Algonquin Backcountry
Recreationalists

Comments Regarding the Algonquin Park 2010-2020 Forest Management Plan

Totem Lake, Wilkes Township

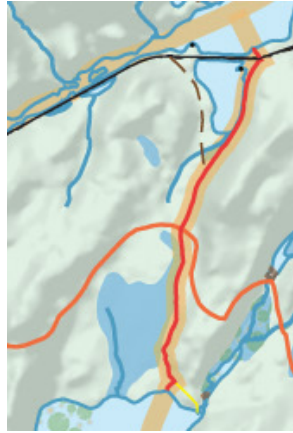
Totem Road

Portage Setback

Totem Road is proposed to be constructed through the portage between Upper Kawa Lake and Totem Lake for a total of approximately 220m. Rather than simply crossing the portage, this proposed road replaces the portage for one quarter of its length.

Little McCraney & Rain Lake, McCraney Township

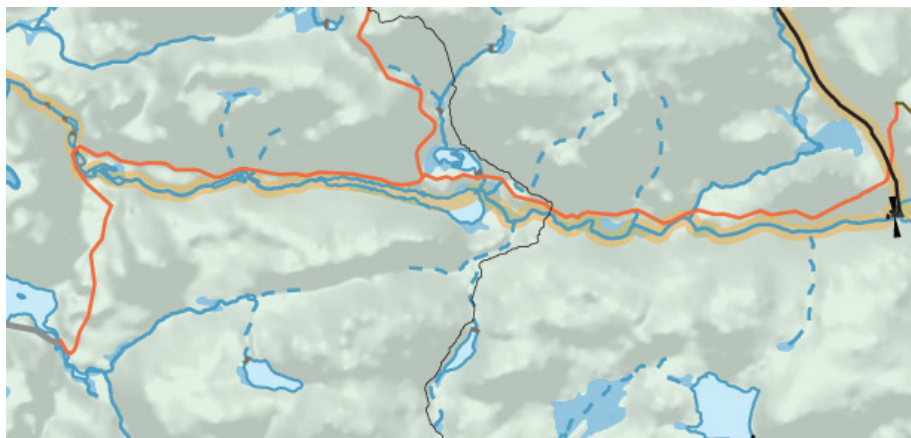
Little McCraney Lake Road

Portage Setback

Little McCraney Lake Road is proposed to be constructed paralleling the portage between Upper Kawa Lake and Totem Lake for a total of approximately 500m at a distance of 50m. As defined by the Algonquin Park Management plan, roads within 120m of portages are crossings yet this represents just under one third of the length of the portage.
